Turbo HD DVR V3.4.1 Release Notes

Reference NO:	PR20151222_02
Product Classification:	Turbo HD DVR
Date of Publication:	December 22, 2015
Edit Department:	Overseas Technical Support Dep

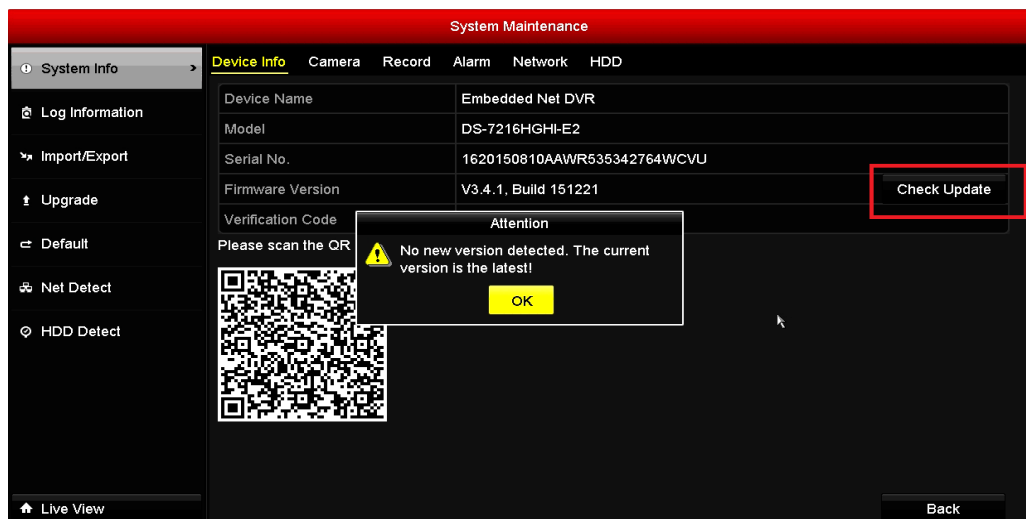
- i. Newly support upgrading DVR firmware version by EZVIZ cloud. When enable EZVIZ function of DVR, there will appear an icon of “Check Update” on the GUI **Maintenance->System Info->Device Info**. DVR will check new firmware on the EZVIZ cloud automatically every day and upgrade once detecting the new firmware. Customer can also upgrade manually by click the “Check Update”.

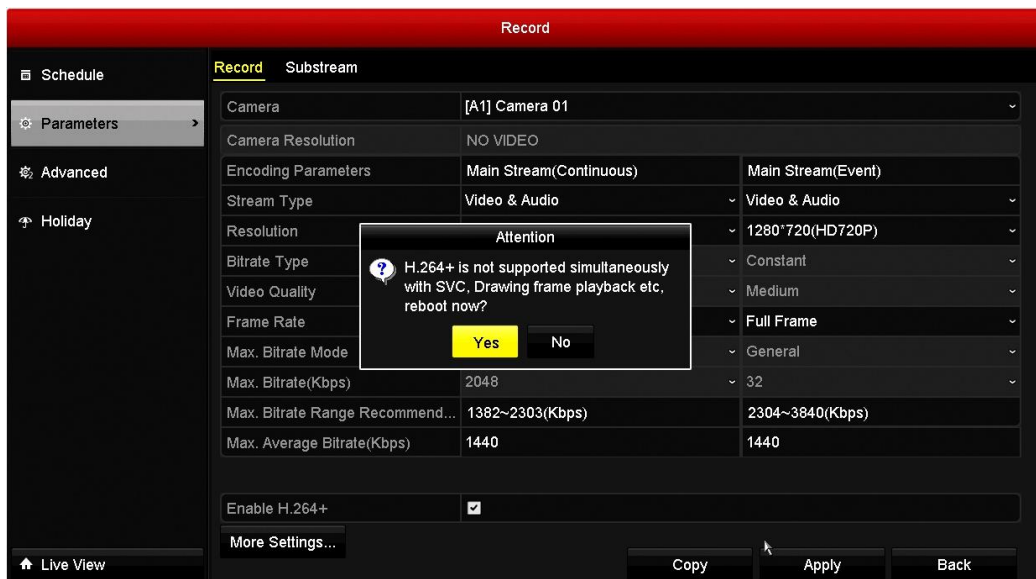
ii. Newly introduce **H.264 +** technology into Hikvision Turbo HD DVRs. Therefore, the encoding efficiency has been highly improved, storage cost and remote live view bandwidth will be saved as well.

a. For analog channels, H.264/H.264+ encoding types are available according to customers' demands.

b. For IP channels, it supports Hikvision IPCs which support H.264+ (DS-2x22, 2x42 series) access.

H.264+ can also be enabled on DVR local menu (IPC will reboot then) if it is not enabled on IPC side.

Note: 1.H.264+ is conflicted with SVC, Drawing frame playback and Reverse Playback. Players and web components are recommended to be upgrade to the latest versions.

2. For this version, only **HGHI-F** Series support this feature.

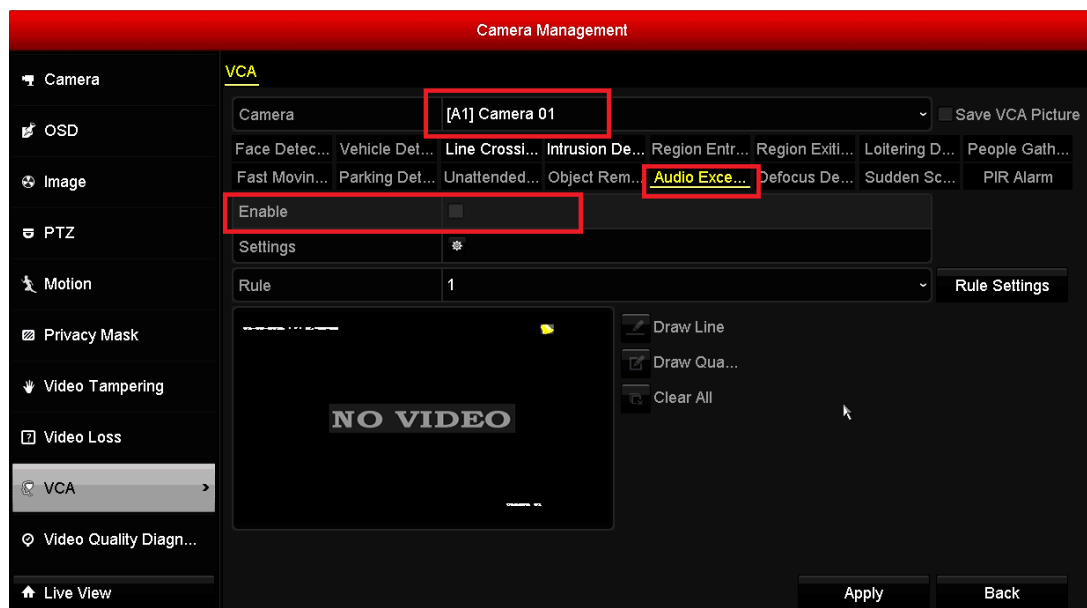
iii. Newly support VCA type **Audio Exception Detection** for first analog channel of 7200 HGHI-E or -F series.

Customers can configure the **Settings** and **Rule Settings**.

- Note:** 1. This feature is only supported for first channel.
2. The “Enable” is grey for this feature is supported by default.
3. In the **Rule Settings**, the lower value of **Sensitivity** is, the audio exception will be detected more easily.

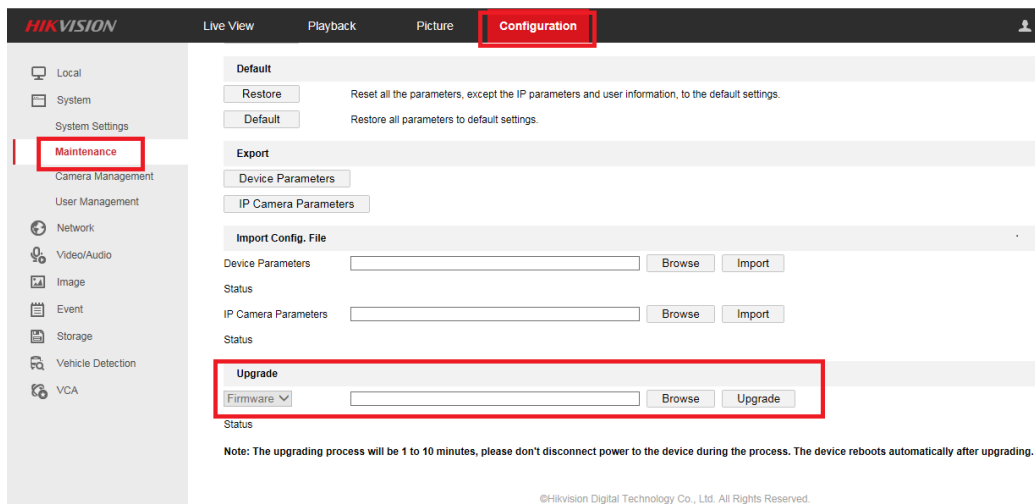
- iv. **Upgrade TVI Camera Remotely:** Newly support function of remote upgrading TVI camera that is connected to the DVR.
- a) **Firmware needed:** In order to upgrade the TVI cameras through SDK/client/ web component, customers need the special firmware provided by support engineers that contains the information of certain channel which the TVI cameras connect to.
- b) **How to:** When updating through the web component, the firmware is input into the same location of DVR's firmware. Our system will judge out firmware is for DVR itself or for the TVI camera and then update automatically. Operation is the same with the SDK or client.
